Economic Commission for Europe

Convention on Road Signs and Signals (1968)

Draft final report of the Group of Experts on Road Signs and Signals

Submitted by the secretariat

A, 15 a (A-15.1) gives warning of a section of road on which there is a particular danger of domestic animals crossing. The symbol shall represent the silhouette of the domestic animal most frequently encountered. The symbol on this sign may be reversed.

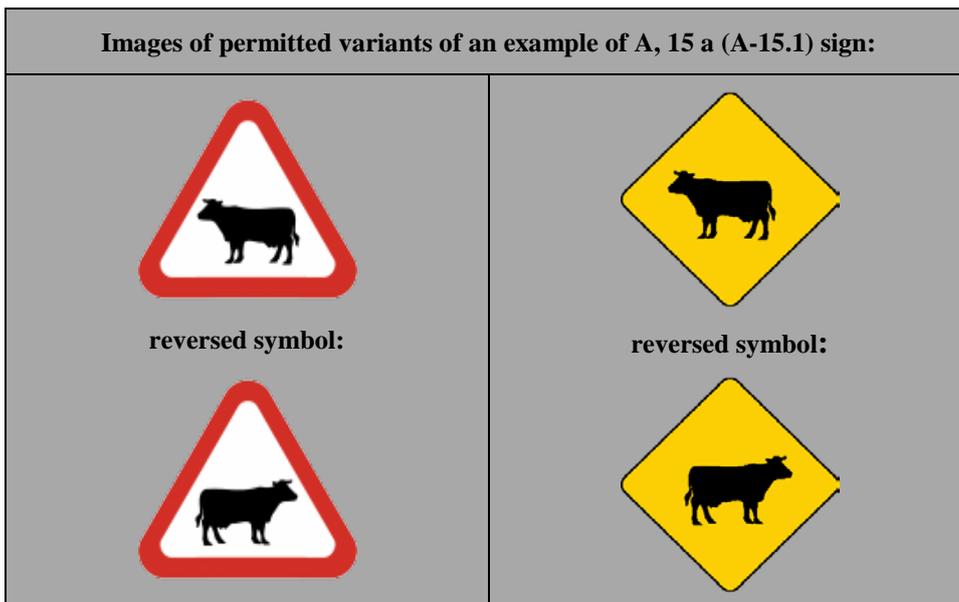
(b) ~~The symbol may be reversed.~~

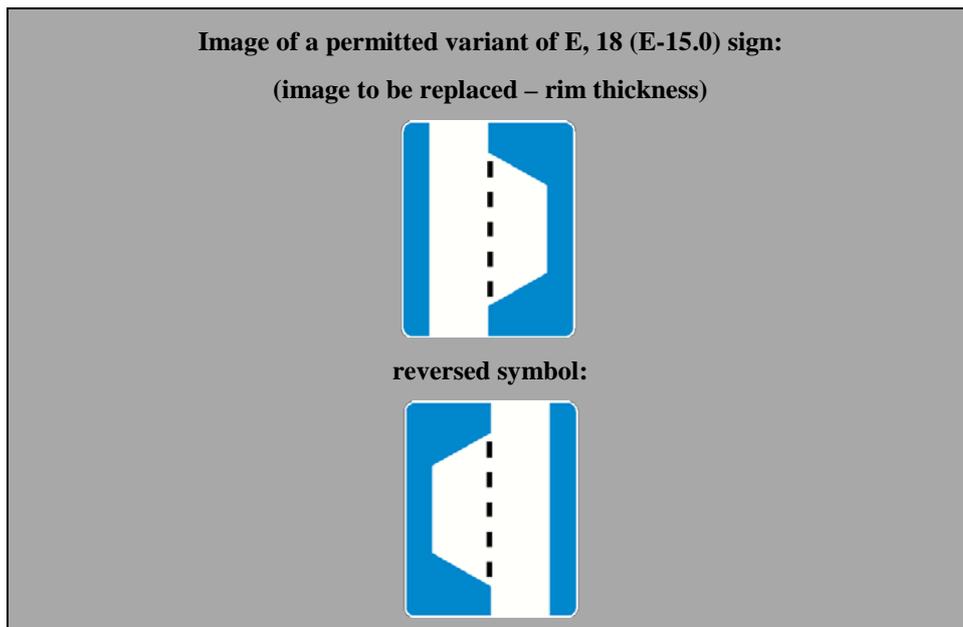
(image to be replaced – rim thickness, house symbol to be improved, thickness of parallel lines)
